From: Cris Simpson *cris.simpson@intel.com*
Date: March 26, 2002
Title: LOGOUT signals: Model concerns

1 Introduction

Figure 1: Interconnect Port Model

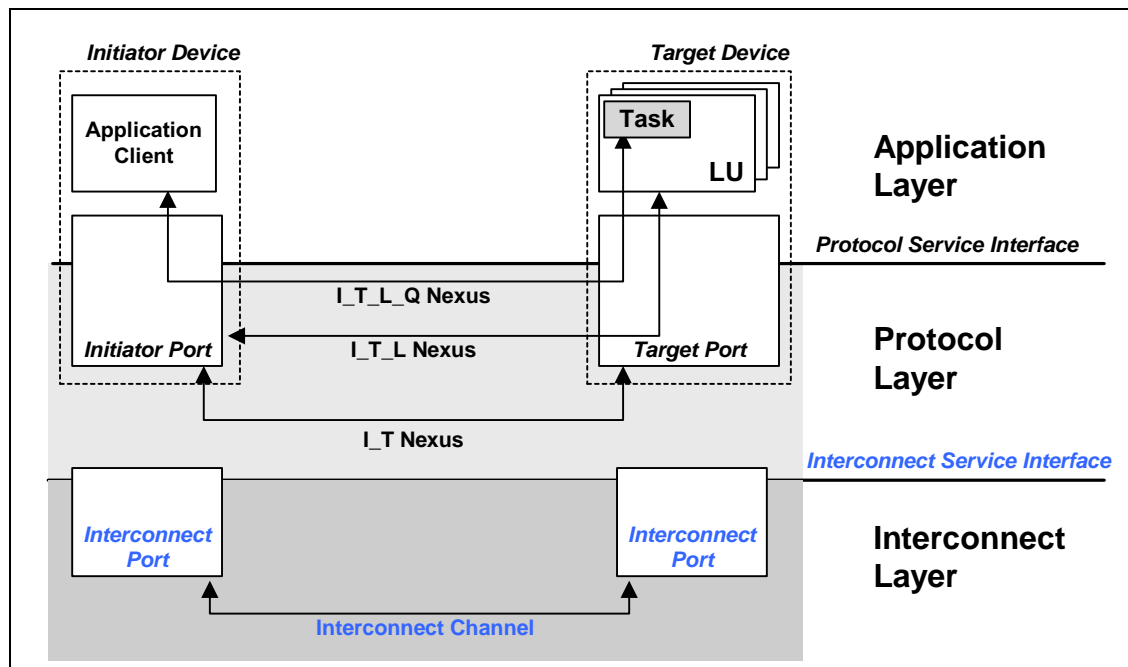
Under general agreement that ‘logout signal’ is a bad term, this document proposes ‘NEXUS LOST’ as the name of the signal by which a logout/disconnect/channel error is reported.

A complete signalling mechanism must consider the interconnect layer, not currently discussed in SAM-2. The figure introduces *interconnect ports*, which serve as the connection between the protocol and interconnect layers. The association of two interconnect ports is called an *interconnect channel*, paralleling the SCSI I_T nexus at the protocol layer. In SRP, such an interconnect channel (IC) is called an *RDMA Channel*.

SRP supports a multi-channel mode in which multiple ICs form a single I_T nexus, but when one of the ICs is disestablished, all tasks delivered to the target over that IC are to be aborted. This suggests the need for another signal, INTERCONNECT CHANNEL LOST. This signal would be sent from the interconnect port to its associated SCSI (initiator or target) port. This is distinct from the proposed NEXUS LOST signal, which presumably would be generated when the last IC of an I_T nexus was disestablished.

Figure 2: Target port model

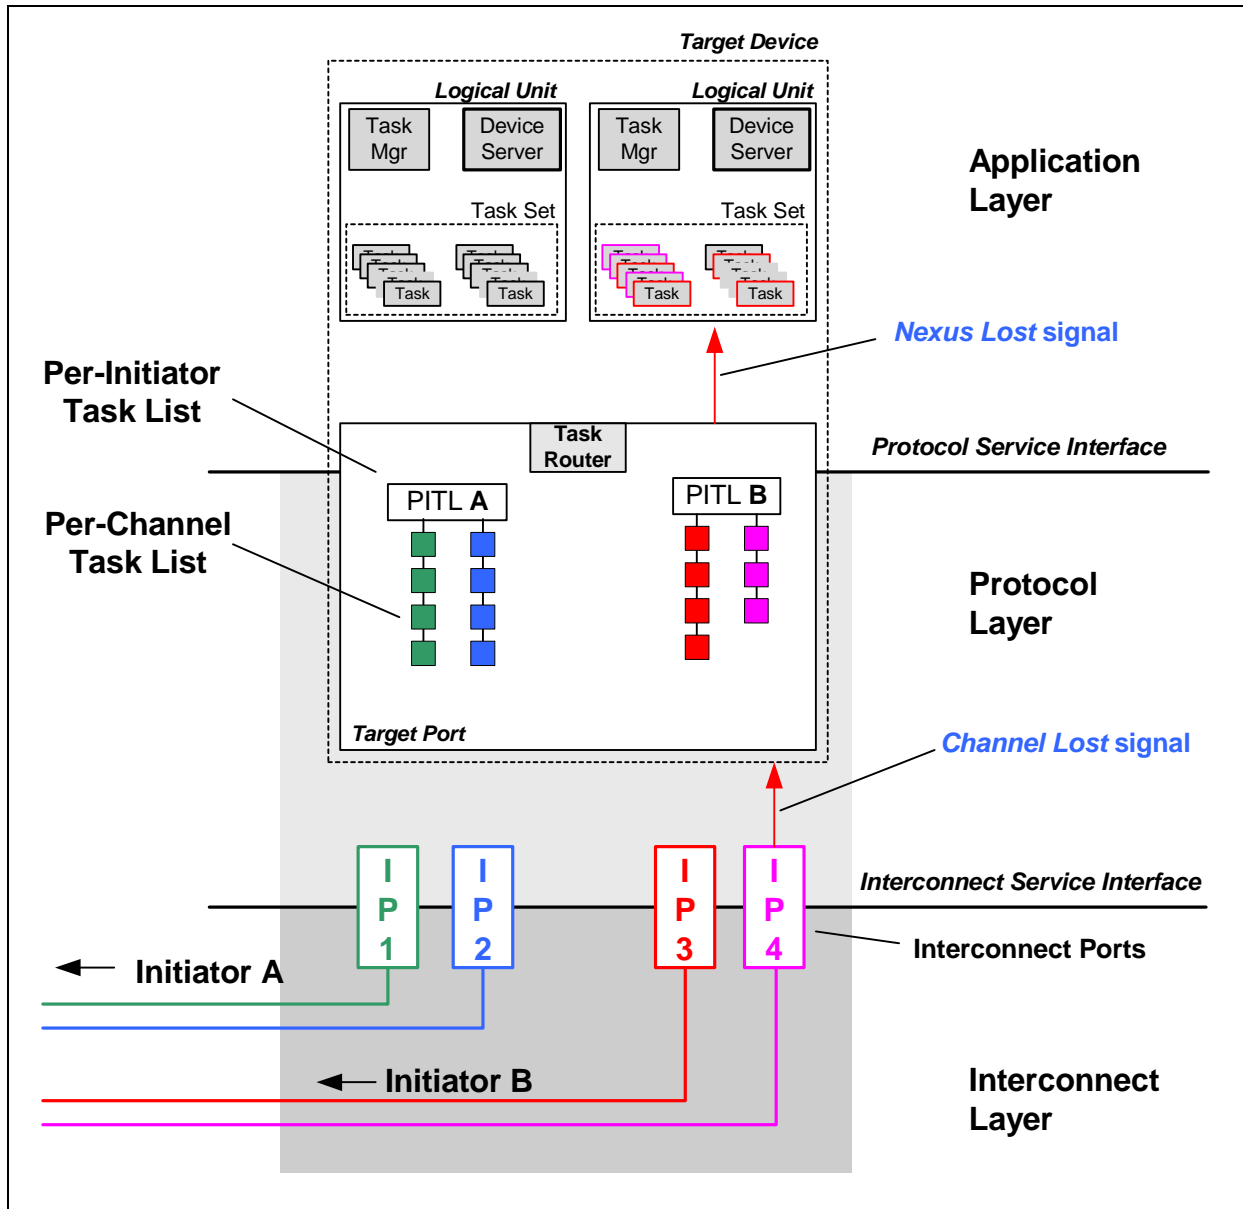
The current definition of SRP's multiple independent channel operation (SRP §5.1.4) specifies that all outstanding tasks delivered to the target over a particular channel are to be aborted when that channel is disestablished. Since channels are not visible to logical units, and there is likely to be little support for changing that model, it appears that the target port must maintain a *per-channel task list* (PCTL) so that the target port can issue ABORT TASK task management requests when the associated channel is disestablished. A well-behaved initiator would ensure that the PCTL was empty before issuing SRP_I_LOGOUT, but there are also other ways that channels are disestablished. (*Should the target port issue the task management requests as the initiator?*) The union of PCTLs associated with a particular initiator is called a *per-initiator task list* (See Figure 2).

Neither SRP nor SAM-2 define the order in which tasks are to be aborted. Initiators that depend on the ORDERED task attribute to control execution order could suffer data corruption if an ORDERED task was aborted before the the task it was blocking. Strong execution ordering is a Good Thing, in that it allows initiators to launch several commands at once, eliminating the need to take a context switch for every commands that completes. I see two options for enabling strong ordering: we could either specify an order for aborting tasks (youngest to oldest), or a means to prevent tasks from a specified initiator from entering the enabled state (e.g., FREEZE_INITIATOR_TASKS, RELEASE_INITIATOR_TASKS).
